VACC Input to Stanley Park Cycling Master Plan

VACC Vancouver/UBC, Stanley Park Proposals, 2011.09.30

The numbers in the map refer to the subsequent proposals.

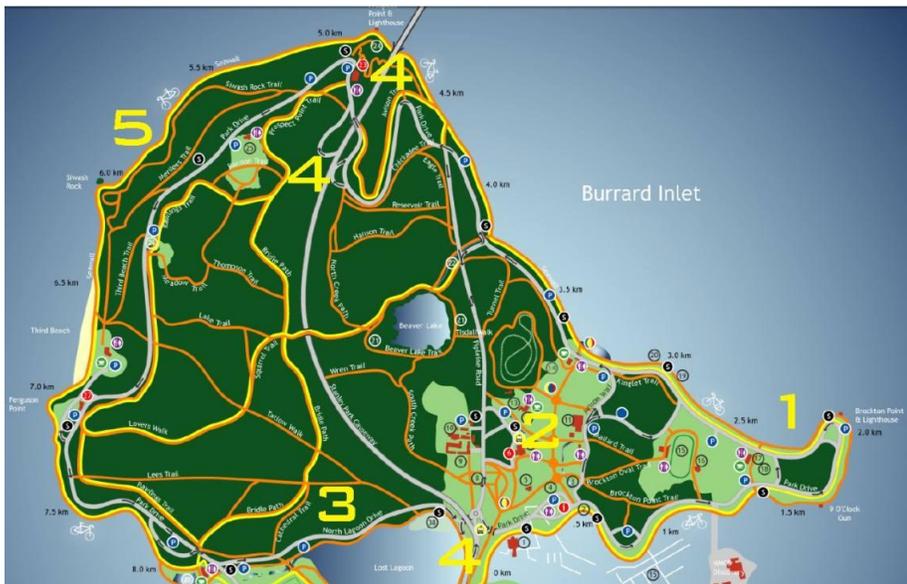
1 — Brockton Point and the Totem Poles.

We would like to see it possible to be able to go back directly from here to the Park entrance at Georgia Street. One could follow the Beaver Lake and Lovers Walk trails, however there is no safe way to access this trail without riding on a road with traffic. Return is also possible via Pipeline Road but this road does not even have bike lanes.

- a) Create a two way separated path on or parallel to Pipeline Road.
- b) Widen the Seawall Path to be a two way path between park entrance and the Aquarium.

2 — Vancouver Aquarium.

There is currently no way to access the Aquarium by bike without riding with traffic on Avison Road or walking one's bike on a walking path. Even then, there is no safe way to return to the city without either walking one's bike on a walking path or riding all the way around the Stanley Park seawall. At a minimum, a two-way cycling path should be built on or parallel to the Avison road. For a shorter return path, one could use one of the two options described above.

3 — Connecting Second Beach and the beginning of the Stanley Park Drive at the roundabout.

It would be an enhancement to be able to connect these points with a two-way bike path along Lost Lagoon Road. The current road is somewhat over-dimensioned for the amount of traffic (one lane used to be reserved for a bus), and is, except at Second Beach, wide enough. The best option would be to install a physical separation between bikes and motor vehicles..

4 — Along the Causeway.

5 — Along the Seawall.

6 — Throughout the Park.
